SVE Associates

RE: Walpole – Ruggiero Processing Facility, 32 Industrial Park Road
Permit #DES-SW-SP-12-001

In response to your letter dated January 8, 2015:

SITE PLAN
LAND OF
RUGGIERO PROCESSING FACILITY, LLC
located at
Tax Map 1, Lot 10-2
32 Industrial Park Road, Walpole, Cheshire County, New Hampshire

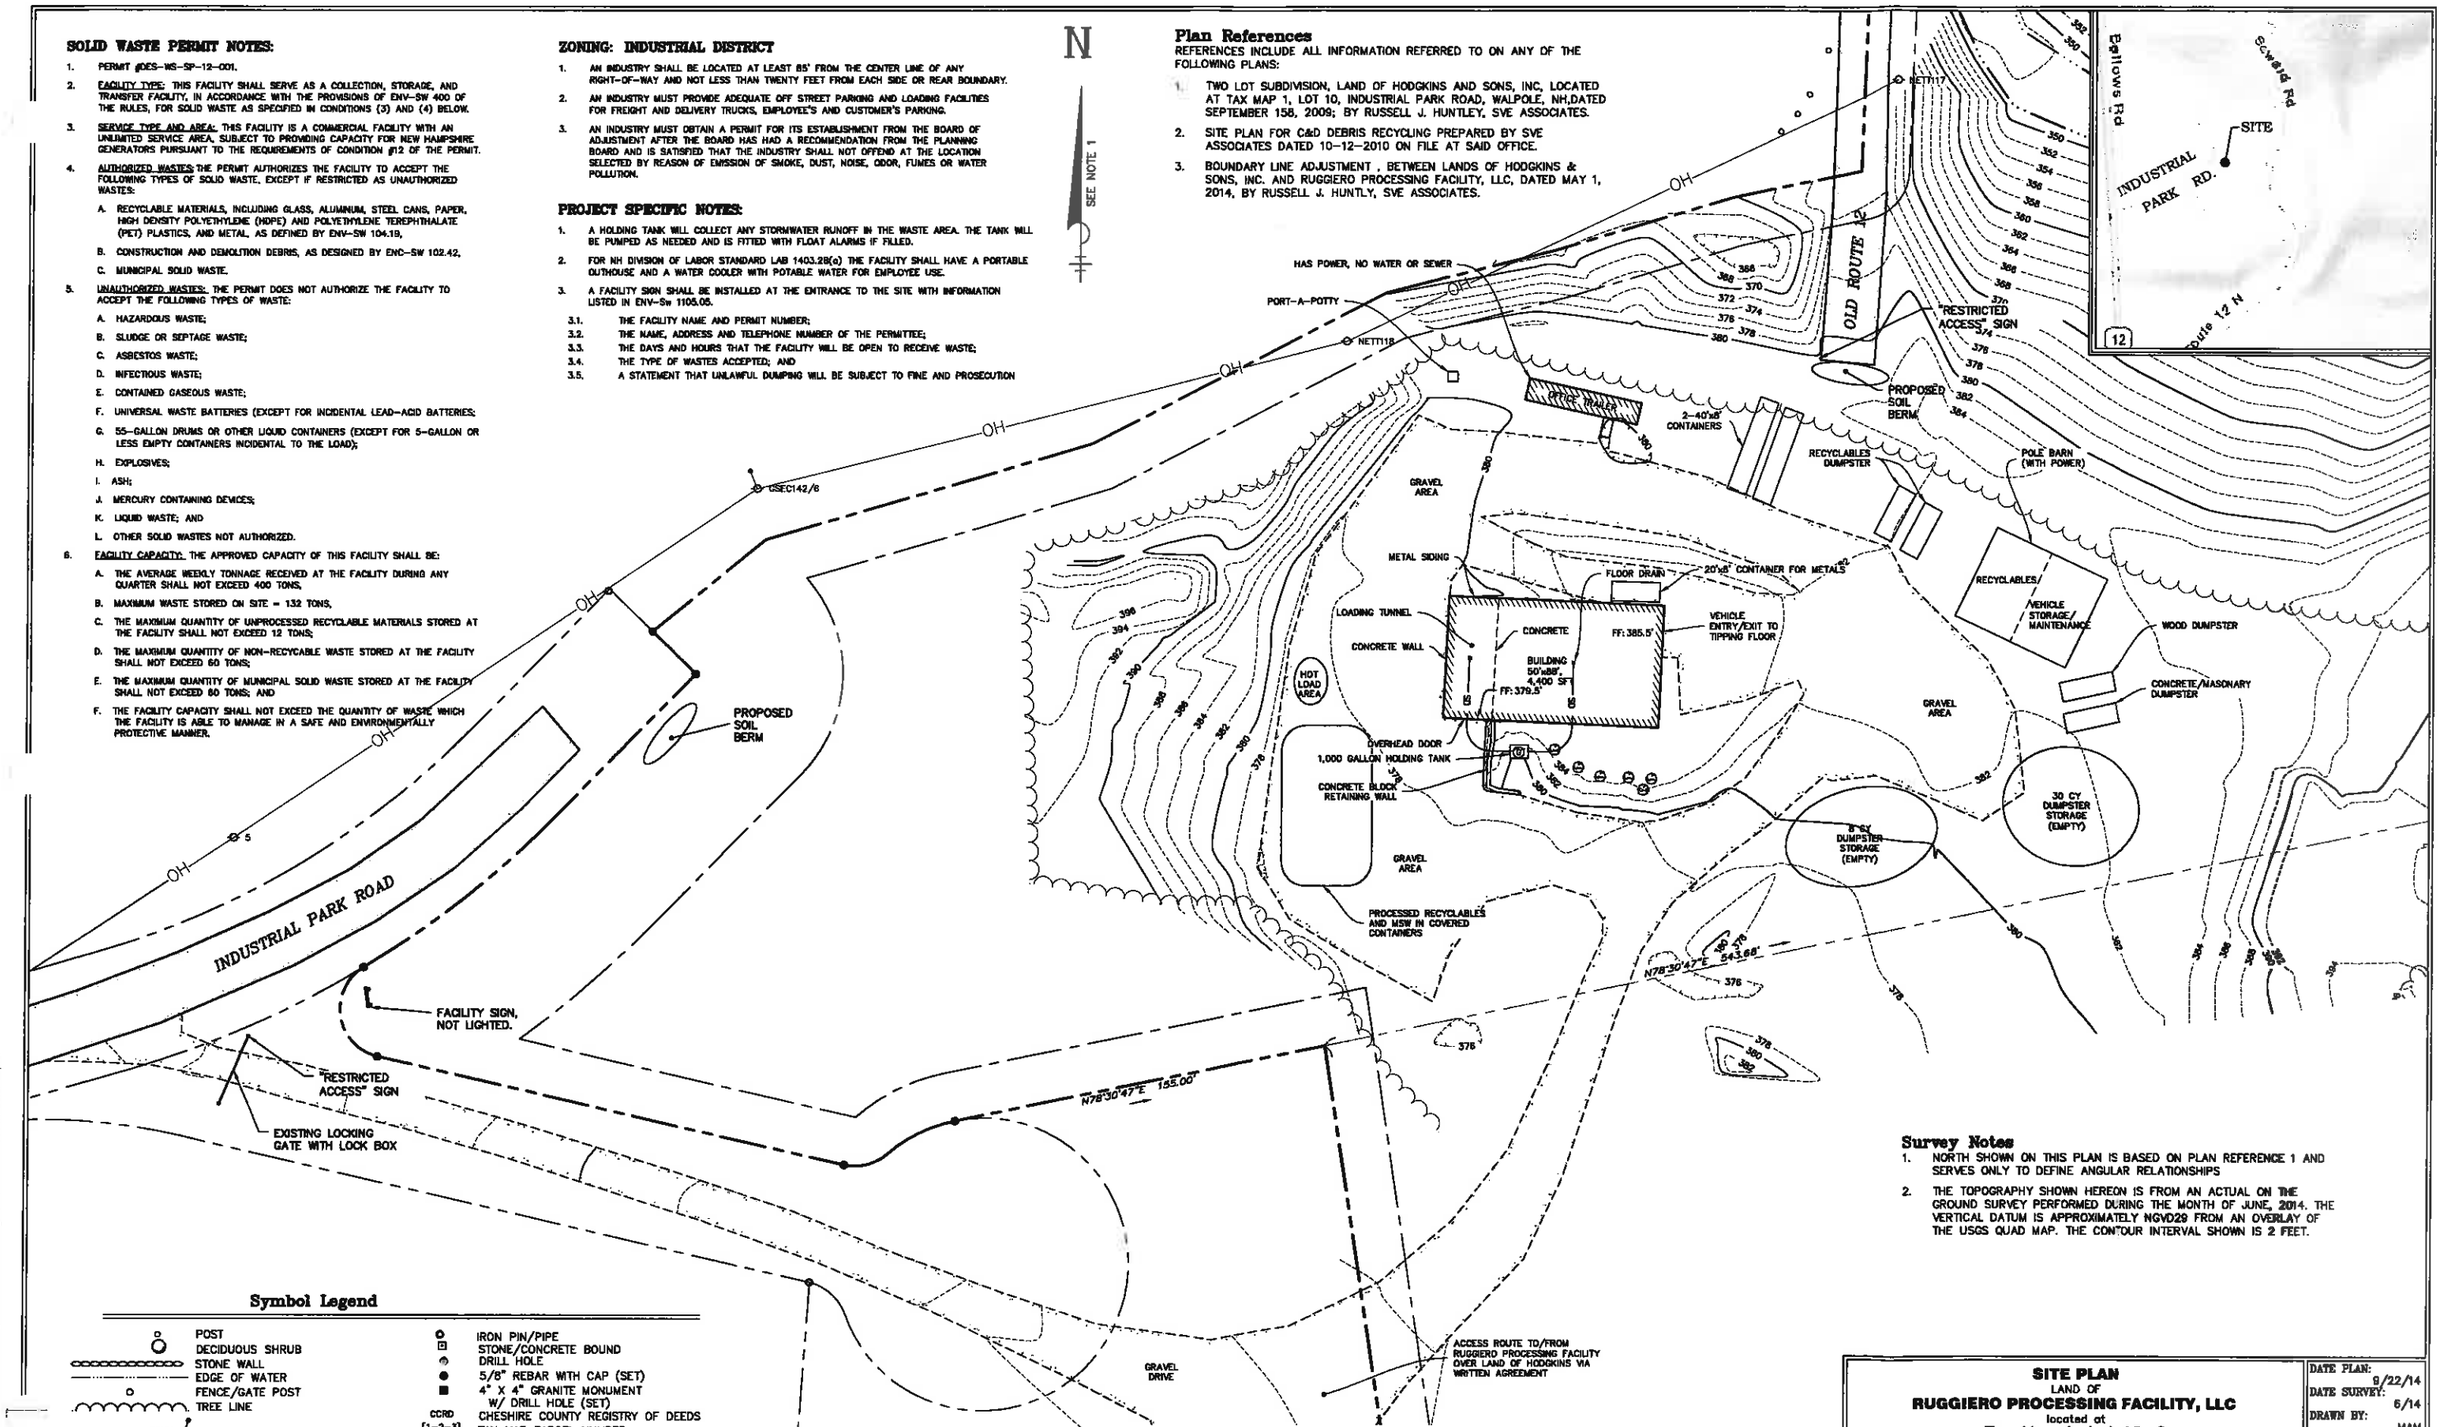
11. *The Site Plan shows access is through a lot to the south of the property. If this lot is not owned by the permittee, please provide an access agreement with this property owner. Please describe this agreement in Section 3.02 of the Operating Plan.*

14. *In Section 3.02(2)(c) it is mentioned that MSW may be temporarily stored in a loaded trailer in the staging area. Please show where this staging area is on the Site Plan. Please also describe in Section 5.05 what odor control measures will be used during this temporary storage time.*

20. *On the Site Plan, please show the masonry and concrete products, metal wood, and non-recyclables listed in Section 3.07.*

22. *Please place on the Site Plan the hot load area mentioned in Section 6.01(3).*

34. *Please show where the different wastes are stockpiled inside the building.*

35. *Please show the access routes to and from the building. Explain if the "entry/exit to tipping floor" is for a vehicle or a person.*

40. *The plan title of "Land of C&D Debris Recycling" does not include all of the materials, such as MSW, that the facility accepts. Please explain.*

Ruggiero/Hodgkins had a boundary line adjustment approved by the Walpole Planning Board subsequent to our prior approvals, so Ruggiero now owns much, but not all of the land now used to access the site. A binding written agreement between Ruggiero and Hodgkins is attached.

The reference to staging area refers to either the loading tunnel or the area designated for storage just to the southwest of the building.

The masonry/concrete, metals, and wood are deposited directly into roll off dumpsters. They are not stockpiled on the ground.

We noted the "hot load area" on the Site Plan.

We added a note to the plan indicating that the driveway leading to the building from Industrial Park Road is both an access as well as an egress route. The "ENTRY/EXIT TO TIPPING FLOOR" indicates the location of the overhead door the trucks drive both into and out of.

We added a list to the site plan of all materials, such as MSW, that the facility is allowed to accept, a list of what is NOT allowed, and we changed the title of the plan to SITE PLAN.

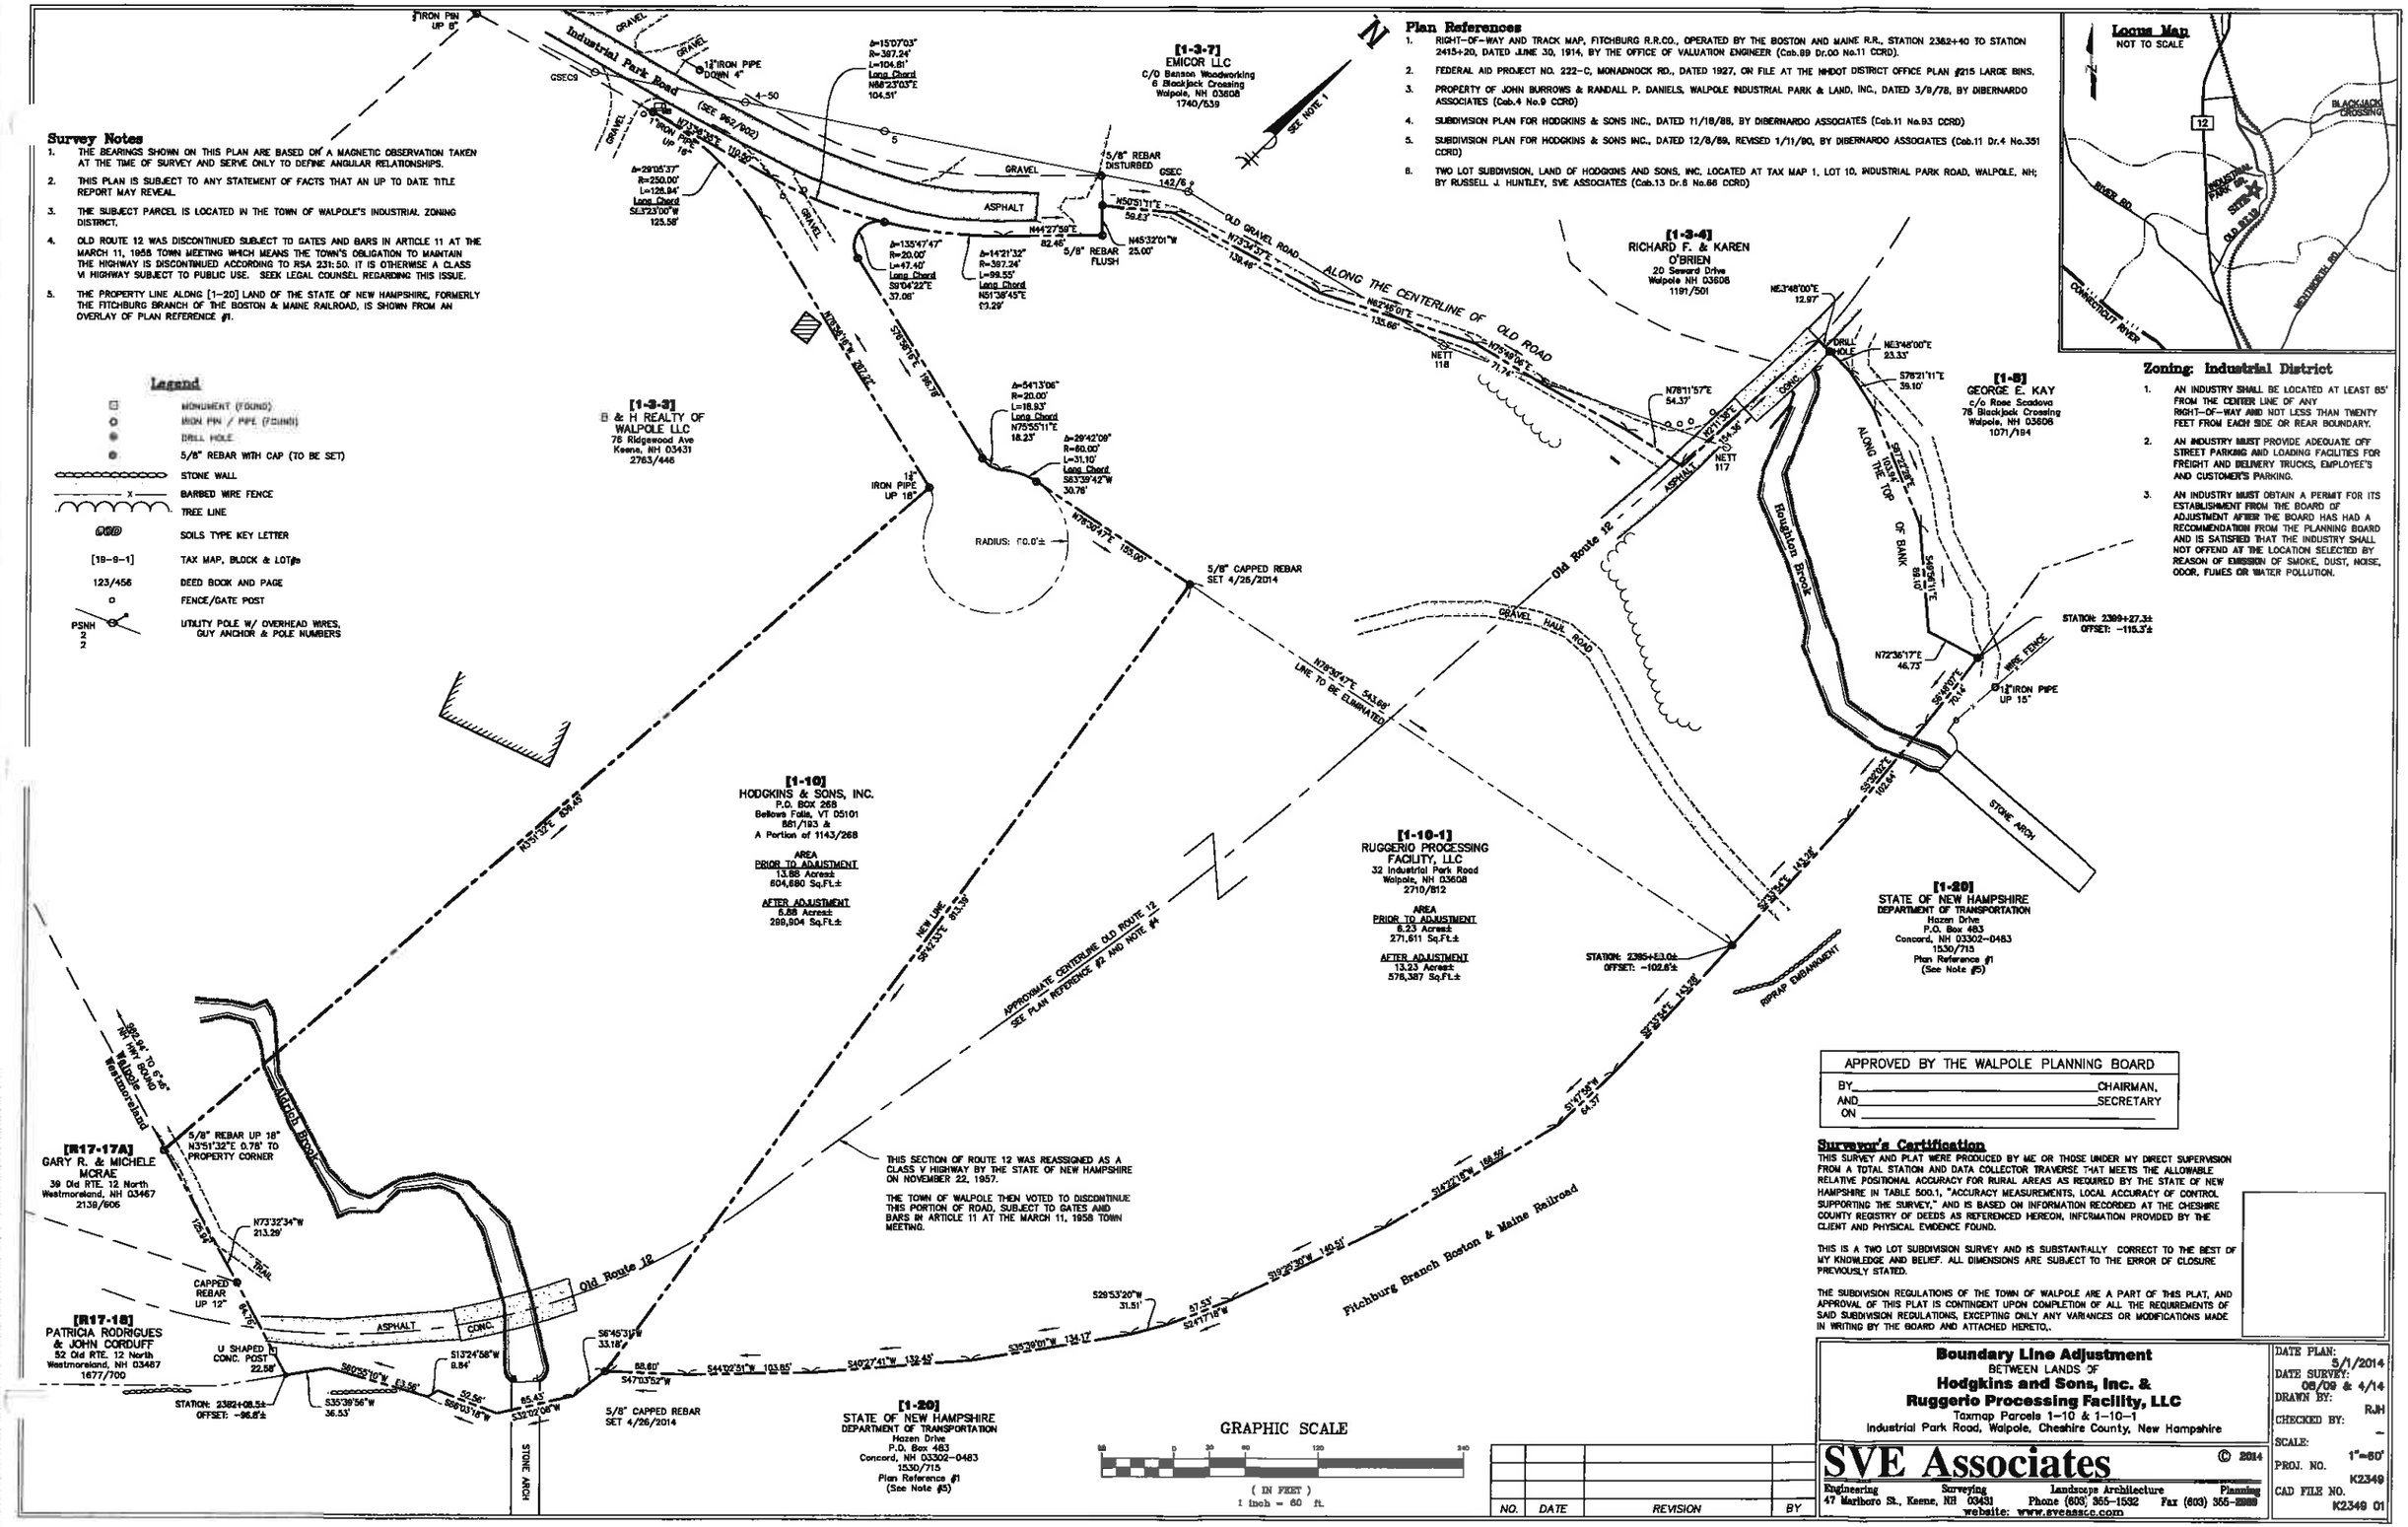
39. *Please provide a current "Two-Lot Subdivision" plan showing all abutter, lot, and easement information.*

The latest plan, a Boundary Line Adjustment plan depicting abutters is provided herewith. Also provided is a current Walpole tax map. We highlighted the properties noticed in the last application. We will notice the same property owners again. The abutters list will be updated once you agree the application is complete and ready for public hearing.
